MEETING ON RECALCULATION OF  
SEISMIC RESPONSE SPECTRA:  
COMANCHE PEAK

Location: Bethesda, Maryland  
Date: Tuesday, June 18, 1985

3  
4 MEETING ON RECALCULATION OF SEISMIC RESPONSE SPECTRA:  
5 COMANCHE PEAK

AUXILIARY BUILDING  
FLOOR RESPONSE SPECTRA  
FSAR vs RSI RE-ANALYSIS

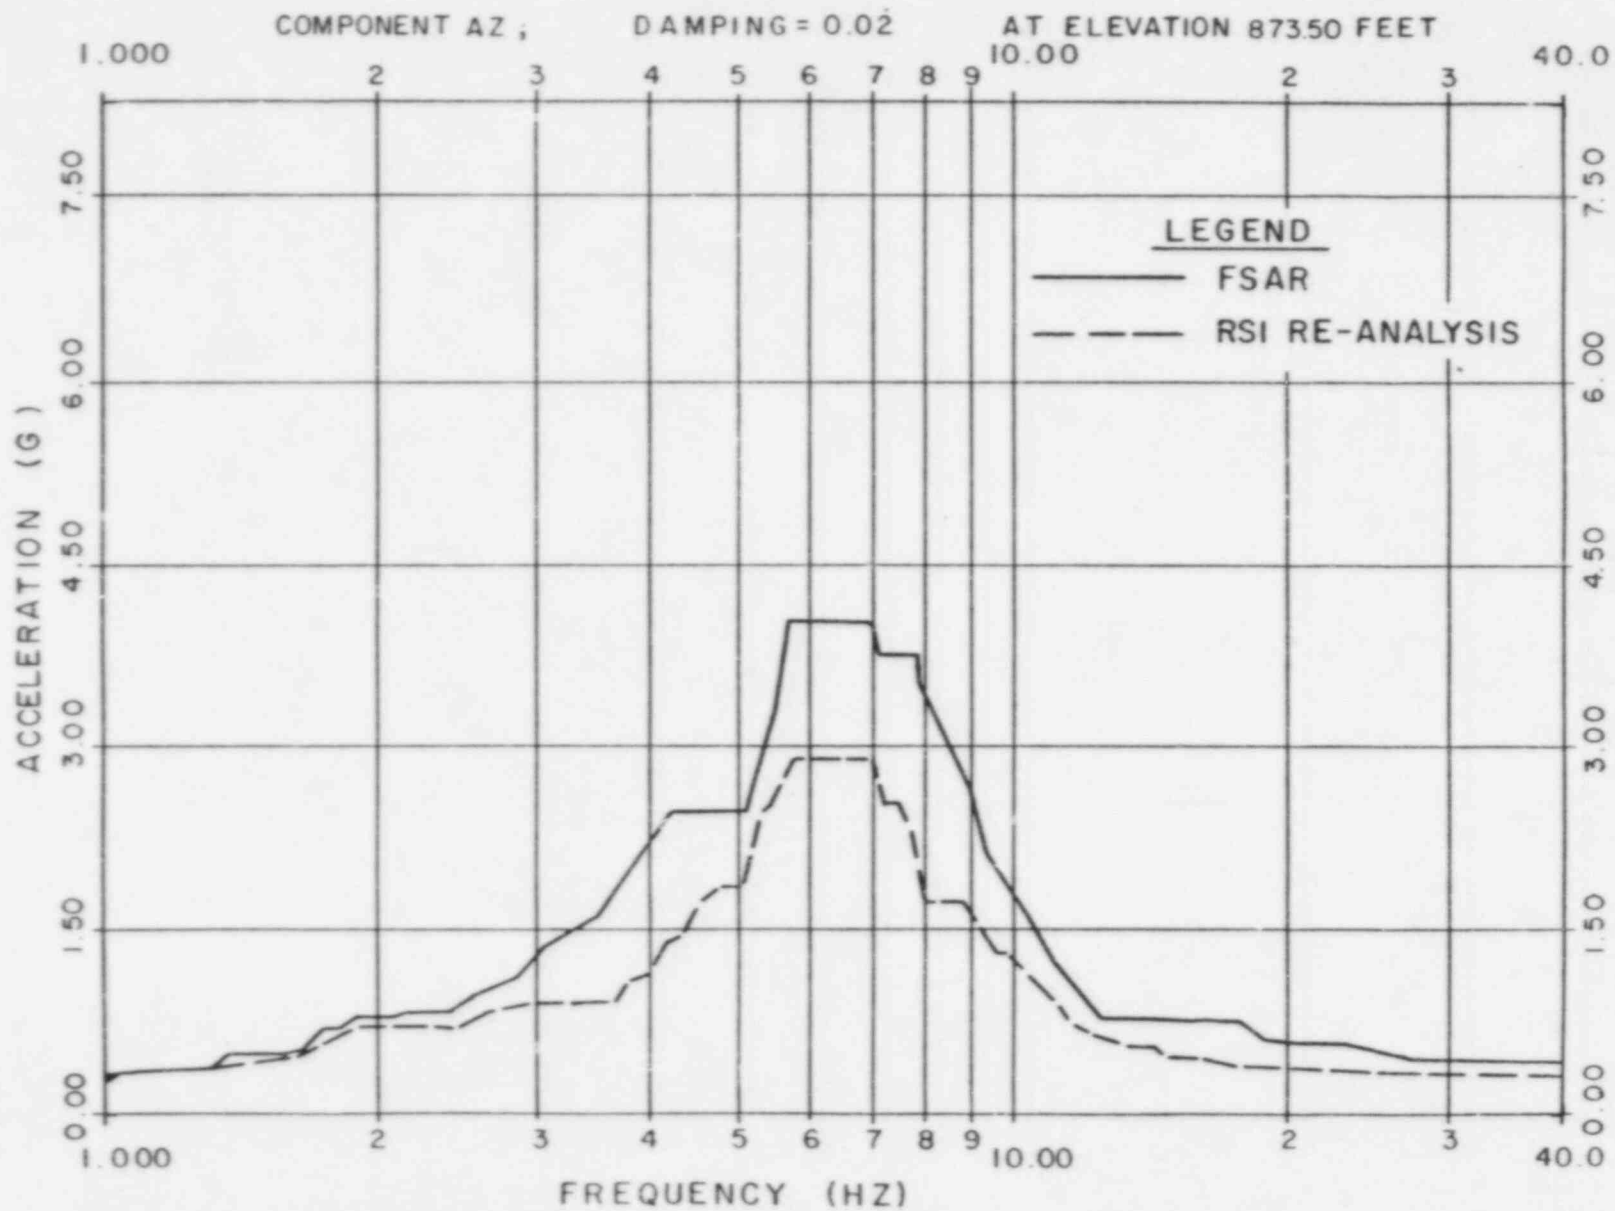
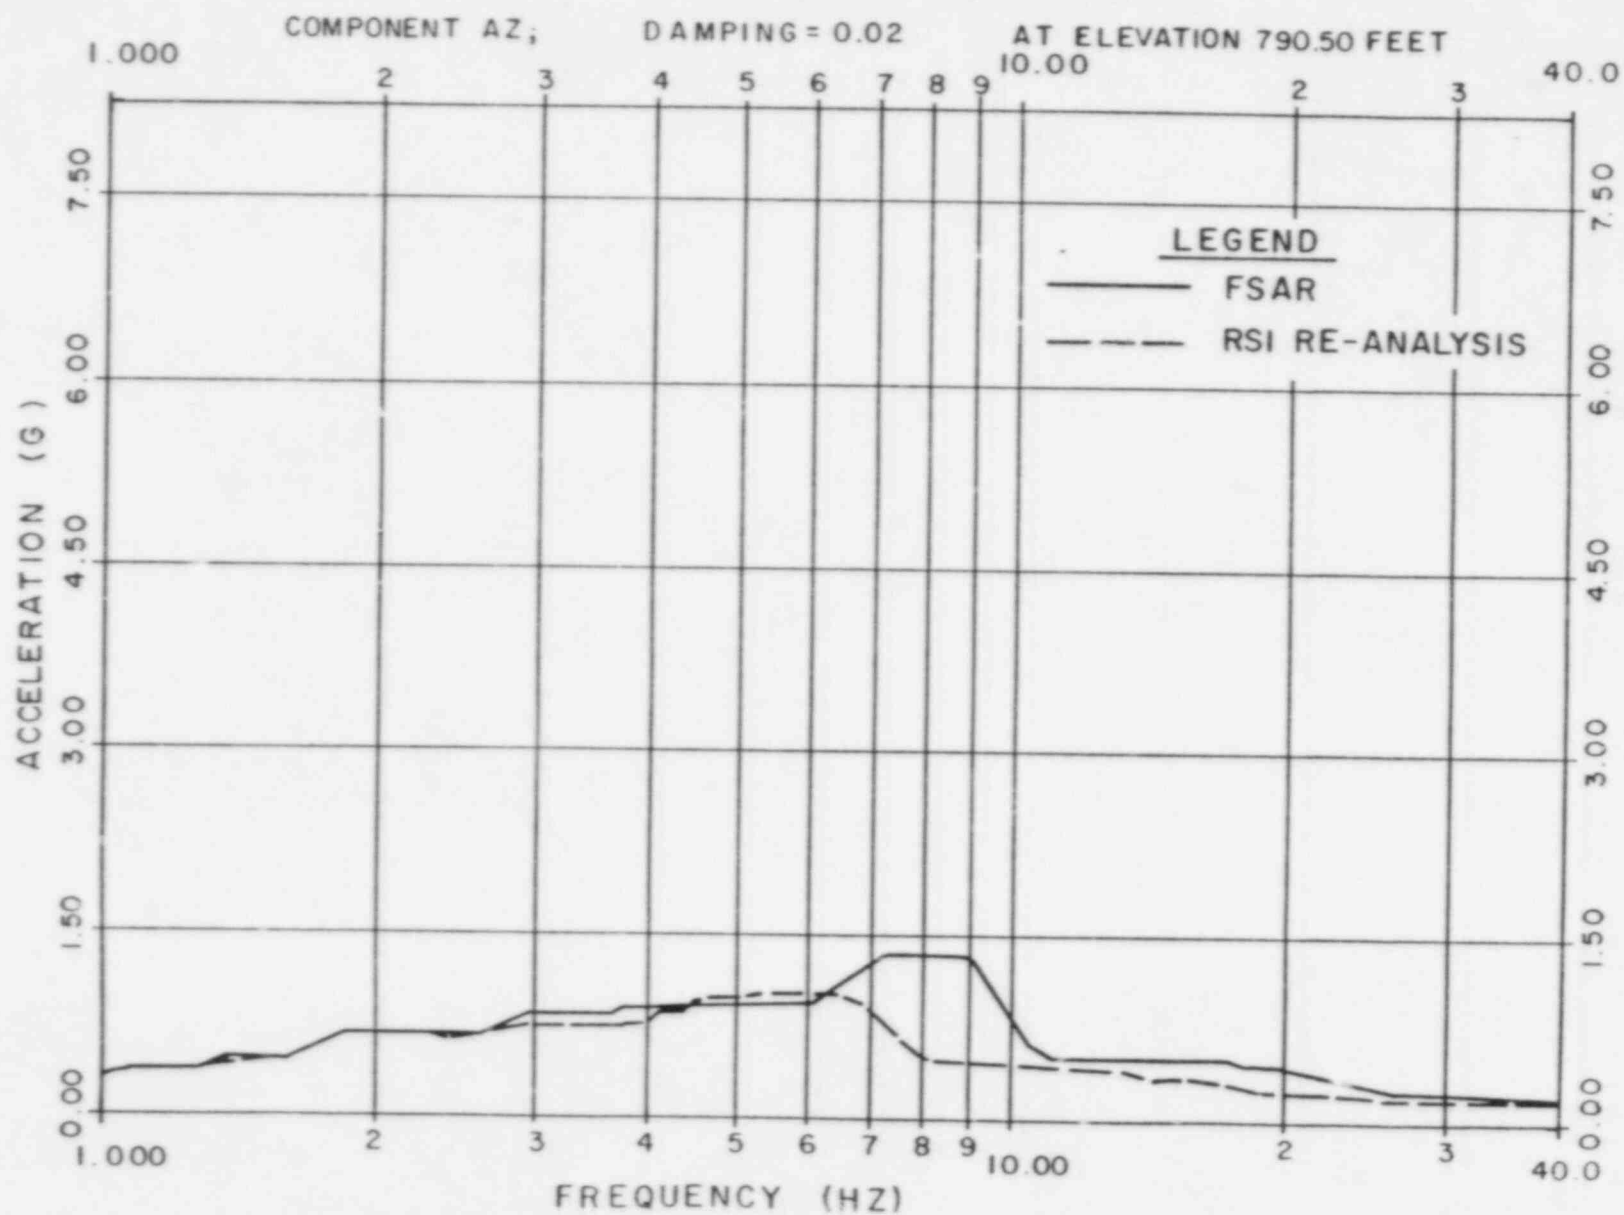
4 MR. JENG: How about the effect that you are finding  
5 the rocking and torsion increase by ten times? Would that be  
6 a major contributor in the reduction of the upper level  
7 response?

16 MR. RINALDI: I have two short questions. One, you  
17 refer to peak broadening. You use plus and minus 10 percent.  
18 I want to caution you that the new requirement is 15 percent  
19 unless you can prove otherwise. Just a comment.

20 The other thing is a question basically on the  
21 spectra you showed for 2 percent damping. Can you comment on  
22 5 percent damping? Is there significant change from what you  
23 show?

18 MR. CLOUD: On the issue of the peak broadening, I  
19 guess we have felt that the Standard Review Plan was slightly  
20 different than you stated it. We felt that it called for 15  
21 percent, but that 10 percent would be acceptable, provided it  
22 was justified with additional studies.

2               In our view, that satisfies this approach  
3       (indicating). Any reasonable method for determining the  
4       amount of peak widening, and we add 10 percent on top of  
5       that. It says "plus or minus." We take 10 percent on top of  
6       the widening.
